**Reference: 750 Old Highway 24 – Site Plan Application – Phase 1 Submission 3
Verlinda Homes, Waterford, Norfolk County
Our Project 20-128**

G. Douglas Vallee Limited is the agent acting on behalf of Verlinda Homes regarding a site plan application with Norfolk County. Please accept this package as our formal third site plan application for a commercial / retail development located at 750 Old Highway 24 in Waterford.

H:\Projects\2020\20-128 Orchard Square\Agency\Submissions\2024.08.22 - Phase 1 - Site Plan - 2nd Submission\Phase 1 Submission 2 Cover Letter.docx

Drawing Title
SERVICING PLAN

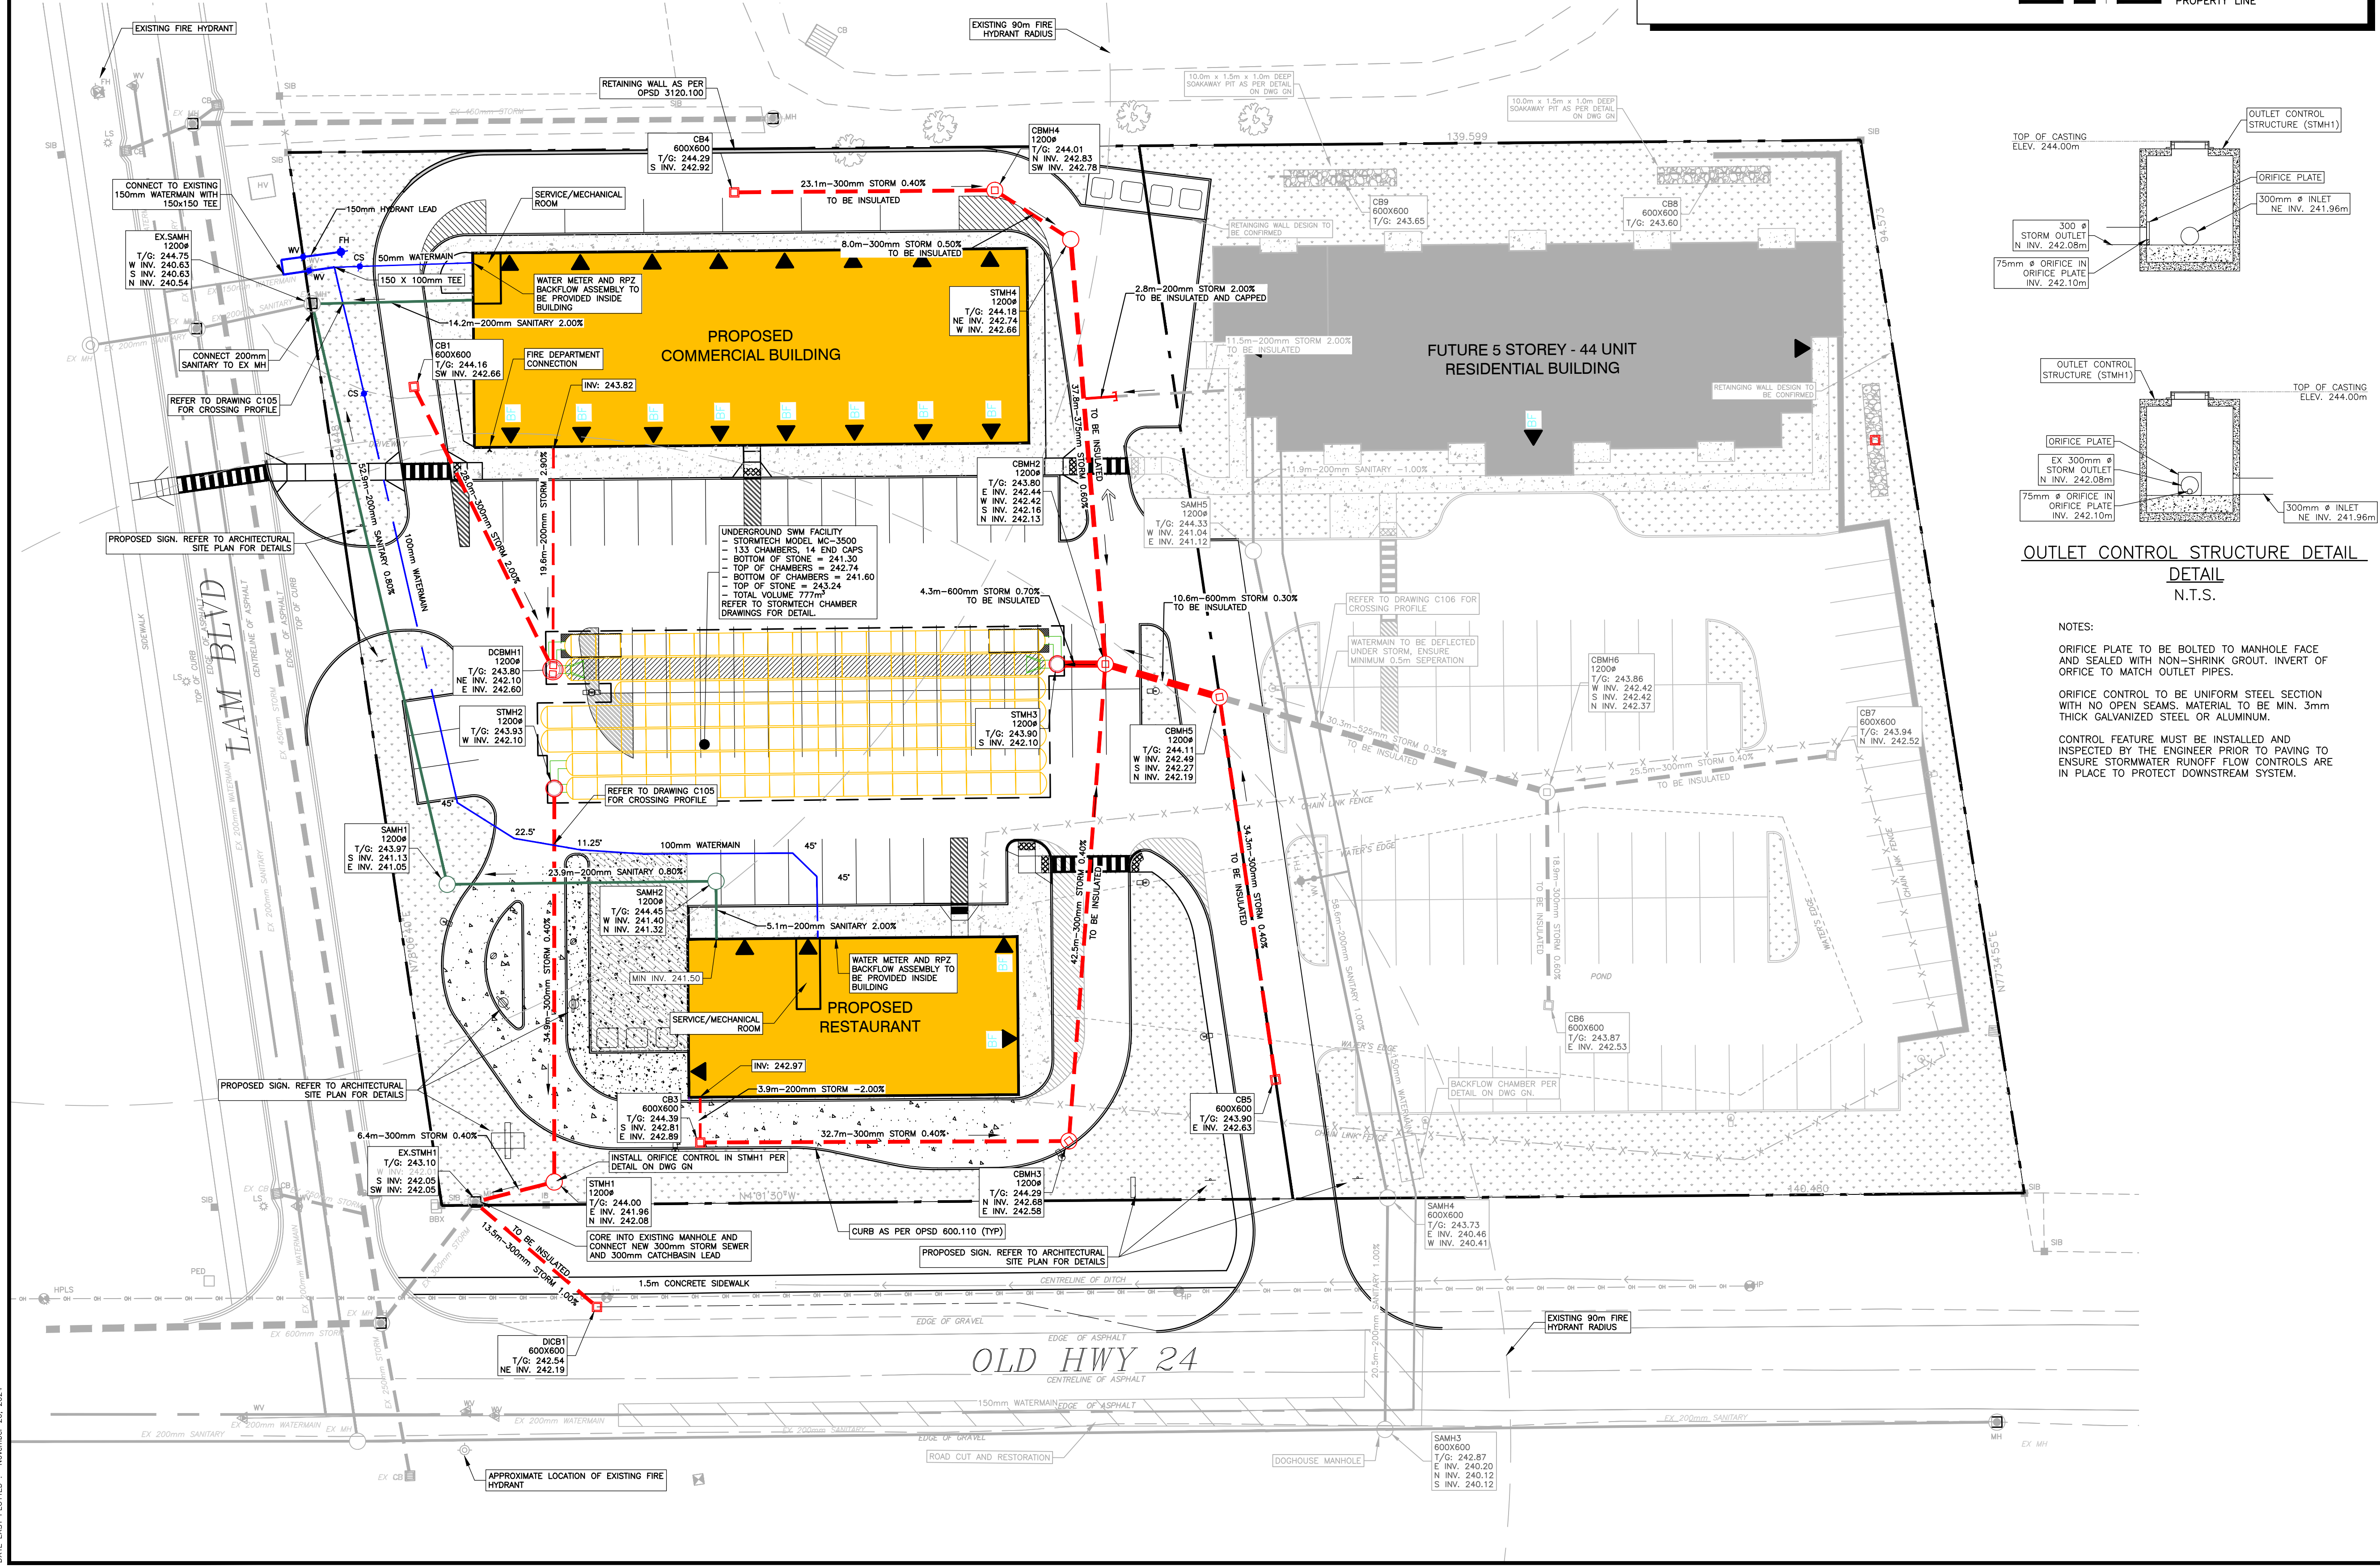
1st Submission	Development Engineering Servicing Plan DWG C101	9	15-Jul-24	All manholes, catchbasins, sidewalks, walkways, valves, curb stops, parking space line painting, etc. to be labelled or shown in legend with existing or proposed identification (labels, line types, etc.);	All manholes, catchbasins, valves and curb stops are labeled on C101. All sidewalks, parking space line painting, etc are shown on Drawing A101B Site Plan and A102 Site Plan Details.	16-Oct-24	Addressed.		Vallee	Complete
1st Submission	Development Engineering Servicing Plan DWG C101	10	15-Jul-24	All new/proposed barrier free parking spaces are required to meet Norfolk County Accessibility Design Guidelines (Section 3.1 Parking).	Coordinate with drawing A101B Site Plan. Coordinate with drawing A102 for all associated parking requirement details.	16-Oct-24	Comment not addressed.	All new/proposed barrier free parking space requirements are shown on Drawing A101B and A102. They will not be duplicated on other plans to avoid cluttering the drawings. Drawing C101 Servicing Plan notes that these details are shown on the architectural drawings.	Vallee - Architecture	Complete

1st Submission	Development Engineering Servicing Plan DWG C101	11	15-Jul-24	Existing (and proposed) property lines and easements are to be shown.	Coordinate with drawing A101B Site Plan.	16-Oct-24	Comment not addressed.	Noted. The existing and proposed property lines are shown on all civil plans. The easement is only shown on drawing A101B to avoid cluttering the civil drawings. Drawing C101 Servicing Plan notes that the easements are shown on the architectural drawings.	Vallee - Architecture	Complete
1st Submission	Development Engineering Servicing Plan DWG C101	12	15-Jul-24	Add a crossing detail at the crossing of the 200mm proposed sanitary pipe and the 200mm proposed watermain.	There is no crossing of a proposed 200mm sanitary and a proposed 200mm watermain. A crossing detail of the Phase 1 water service and the commercial building 200mm sanitary service is from on Drawing C105 which shows adequate vertical seperation.	16-Oct-24	Add a crossing table for all crossings with numerical labels to cross-reference on the servicing plan.	Crossing details are presented on Drawing C106 and C107, which shows adequate vertical seperation. Vallee feels that a crossing table is not necessary for only two crossing locations.	Vallee - Civil	Complete

1st Submission	Development Engineering Servicing Plan DWG C101	13	15-Jul-24	Match the valve symbol to the one shown on Drawing GN.	Noted. The valve symbol has been corrected to match Drawing GN.	16-Oct-24	Addressed.		Vallee	Complete
1st Submission	Development Engineering Servicing Plan DWG C101	14	15-Jul-24	Specify the materials of all pipes.	All pipe materials are noted on Drawing GN.	16-Oct-24	Addressed.		Vallee	Complete
1st Submission	Development Engineering Servicing Plan DWG C101	15	15-Jul-24	The Domestic water service cannot be taken off the Hydrant lead. The Domestic service must be taken off in the ROW and a domestic valve installed at Property line. A sketch received by Environmental Services is attached at the end of these comments. Please contact Development Engineering if you have any questions.	Noted. The hydrant and water service layout has been revised per the sketch provided by Norfolk County.	16-Oct-24	Addressed.		Vallee	Complete

1st Submission	Development Engineering Servicing Plan DWG C101	16	15-Jul-24	In consultation with Norfolk County Environmental Services department, it has been determined that the Backflow Chamber will not be required for Phase 1 of this development. The water meters and RPZ assemblies will be installed inside the buildings. Consultation with Environmental Services to determine the configuration is recommended prior to building permit application.	Noted. The Servicing Plan has been updated to reflect this requirement.	16-Oct-24	Show location of mechanical rooms to confirm watermain building connections.	Noted. Vallee has updated Drawing C101 Servicing Plan to show the locations of the mechanical rooms.	Vallee - Civil	Complete
1st Submission	Development Engineering Servicing Plan DWG C101	17	15-Jul-24	At all proposed crossings, note inverts/obverts and/or show profile of crossing. Separation distances between all services has to be noted on the plan and any separation conflict clearances has to be labelled. Plan and Profile drawings are required as per Section 16.4.03 of Norfolk County Design Criteria.	All proposed crossings are shown Drawing C105, which shows adequate vertical seperation at all crossings.	16-Oct-24	Please confirm this because in the 2nd submission C105 just shows the section plan for the underground storage chambers.	Typo - the correct plans with show all proposed crossings are Drawing C106 and Drawing C107, which show adequate vertical seperation at all crossings.	Vallee - Civil	Complete

1st Submission	Development Engineering Servicing Plan DWG C101	18	15-Jul-24	It is unclear the purpose of placing a new Storm lateral within the Municipal ROW when an existing lateral and property line manhole already exists. Old Hwy 24 was recently paved, and it would be preferred to limit future road cuts if possible. If there is a known issue with the existing Storm infrastructure, please identify it in your next submission.	Noted. The design has been revised to utilize the existing storm manhole at the northwest corner of the development.	16-Oct-24	Addressed.		Vallee - Civil	Complete
1st Submission	Development Engineering Servicing Plan DWG C101	19	15-Jul-24	As shown in this drawing the future Residential building has a Storm connection to the neighboring property in a separate location than the parking lot. Prior to approving this connection location Development Engineering will require confirmation that the Shared Facilities Agreement acknowledges multiple connections to the shared Storm system.	Noted.	16-Oct-24	Further commentary may exist in review of the south parcel application.	No response required at this time.	Vallee	Complete
